UNITED STATES PATENT AND TRADEMARK OFFICE

APPLICATION NO.	FILING DATE	FIRST NAMED INVENTOR	ATTORNEY DOCKET NO.	CONFIRMATION NO.
09/582,817	11/08/2000	Jose Remacle	VANM160.001A	2892

Office Action Summary

DETAILED ACTION

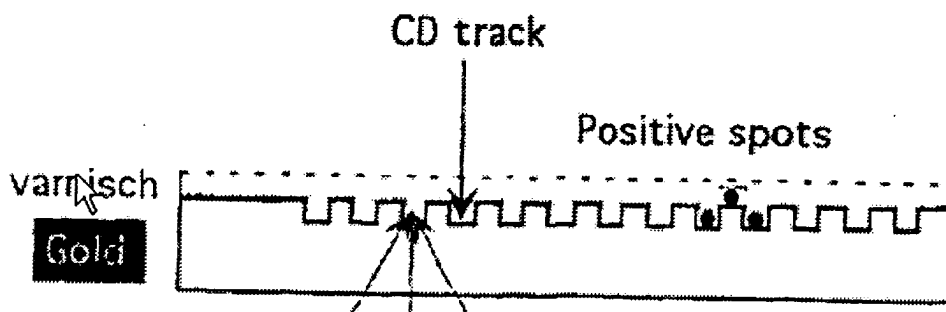
31. Claim 30 is confusing in that the solid surface is to be that of a compact disc (CD) or a digital video disc (DVD), which is recognized as having grooves on its surface. Said claim

requires the solid support (i.e., the CD or DVD) to not comprise “microchannels.” Fig. 3, *infra*, depicts the tracks, which appear to be microchannels.

It is unclear how a CD or DVD, which is recognized as having radial tracks that in essence form microchannels, yet said CD/DVD cannot have any microchannels. (Page 13, third paragraph, of the specification teaches that a CD may up to 20000 different radial tracks.) Claims 31, 34, 40-41, 44-45, 47, and 64, which depend from said claim 30, fail to overcome this issue and are similarly rejected.
